# UNITED STATES PATENT AND TRADEMARK OFFICE

APPLICATION NO.	FILING DATE	FIRST NAMED INVENTOR	ATTORNEY DOCKET NO.	CONFIRMATION NO.
09/986,068	11/07/2001	Kenji Takubo	011314	4716

**Office Action Summary**

## DETAILED ACTION

Fig. 2

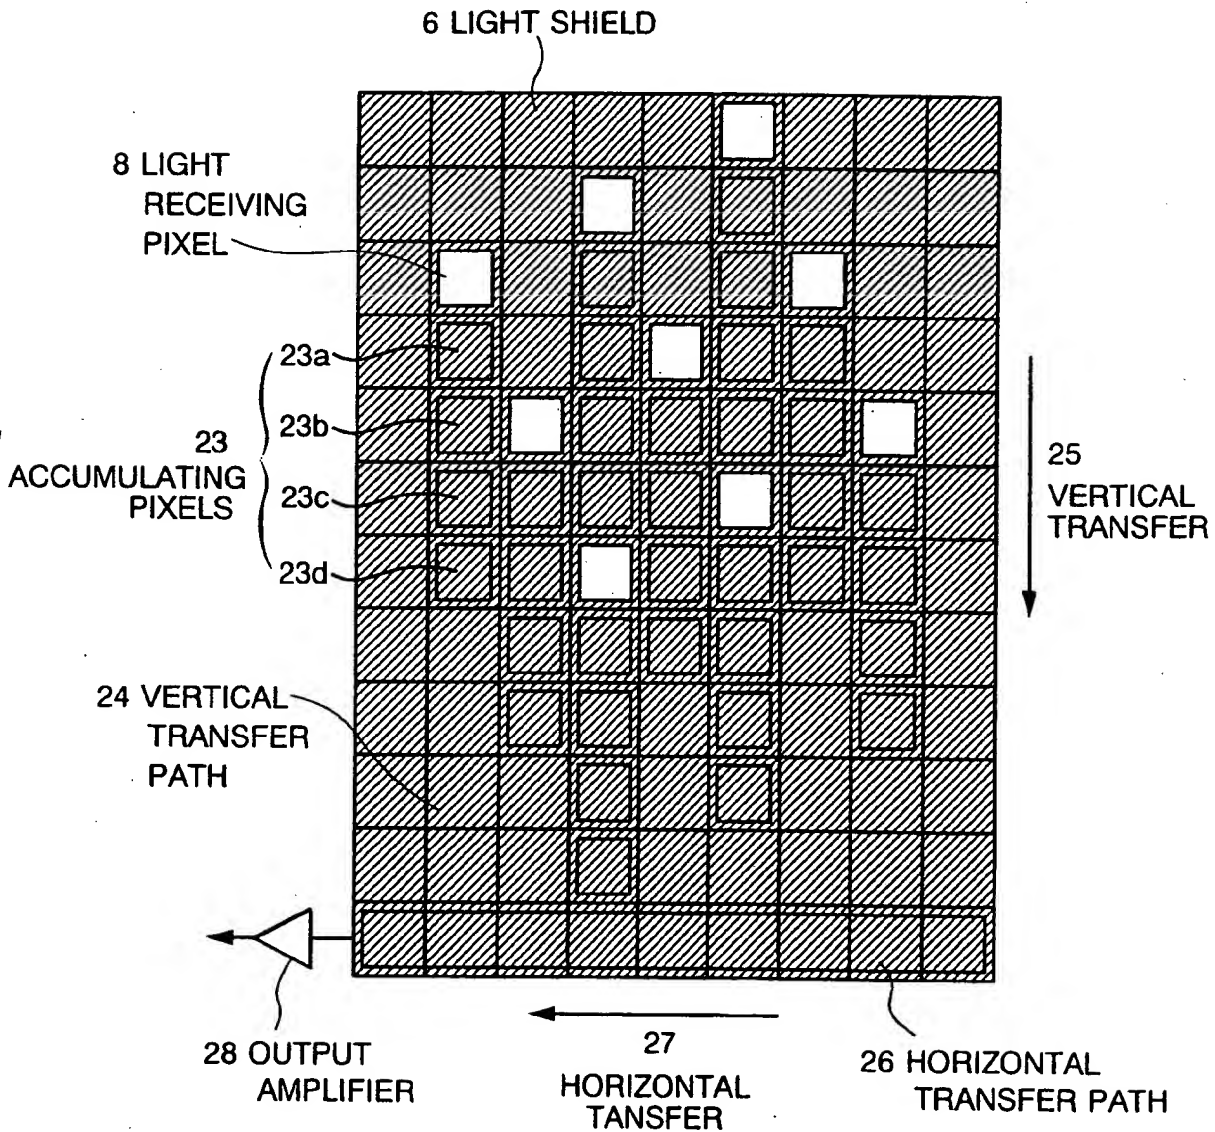
Referring to claim 1, the applicant's admitted Prior Art discloses in Figures 2-3, a solid state imaging device comprising: a plurality of two-dimensionally arrayed light receiving pixels which generate electrical charges according to the incident light (See page 1, lines 10-17); at least two accumulating pixels (accumulating pixels 23a-d, see page 3, lines 14-15) for each of the light receiving pixels (8) for accumulating the electrical charges (see page 3, line 25 and page 4, lines 1-6); a light shield (6, see Figure 3 and page 5, line 1-5) for shutting off light entering the accumulating pixels and having an aperture at each of the light receiving pixels. However, the applicant's admitted Prior Art does not explicitly show an opaque cover having a low reflectivity and laid over the light shield with an aperture at each of the light receiving pixels, and the opaque cover extends into the aperture of the light shield and forms an eave on the edge of the aperture of the light shield.
